**BEFORE THE INDEPENDENT HEARING COMMISSIONERS
IN CHRISTCHURCH**

IN THE MATTER of the hearing of submissions on Plan Change 14
(Housing and Business Choice) to the Christchurch
District Plan

JOINT STATEMENT OF HAZARDS EXPERTS

13 November 2023

Figure 1. Flood Hazard Overlay at the Site (Christchurch District Plan)

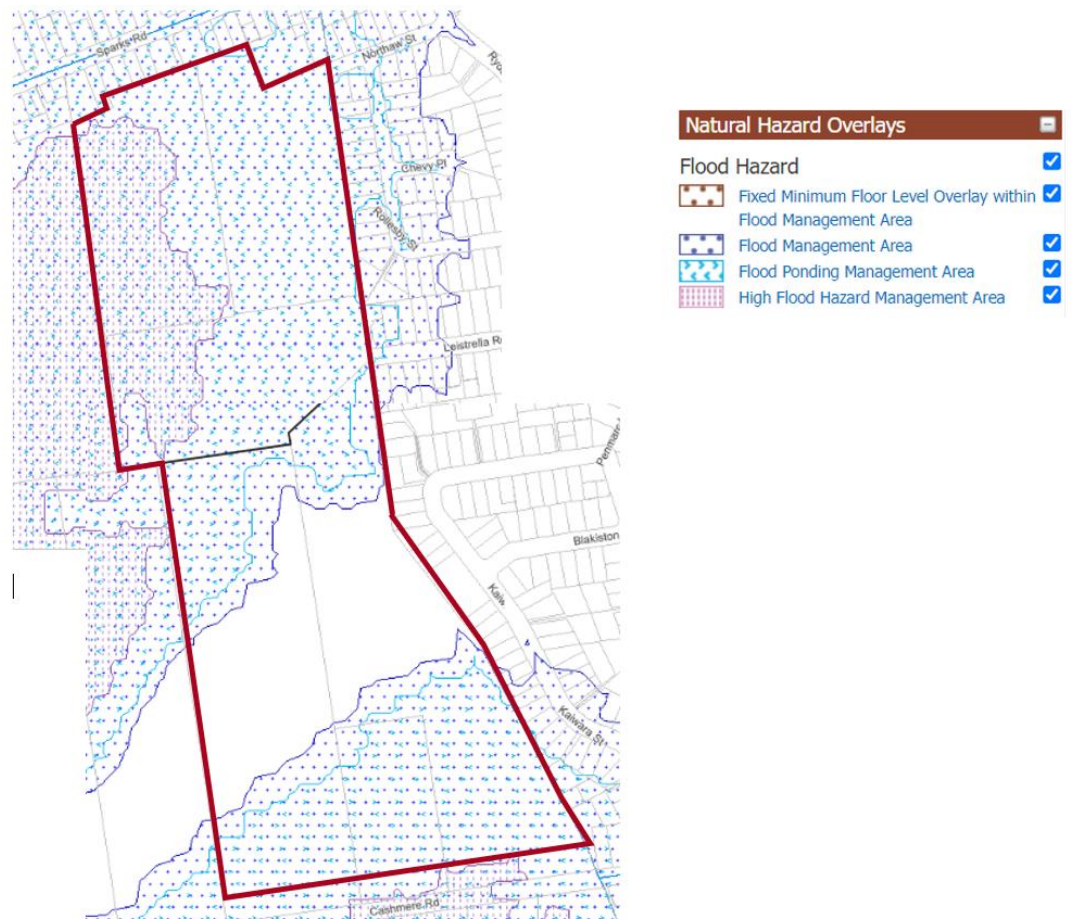
The proposed development site is partially located within the High Flood Hazard Management Area, Flood Ponding Management Area and the Flood Management Area of the Christchurch District Plan Natural Hazard Overlays as shown in Figure 1 below. As demonstrated in the DHI flood modelling report, by providing the compensatory storage within the proposed basins, the overall flood ponding volume within those areas is unchanged and there is no detriment to the ponding storage volume available.
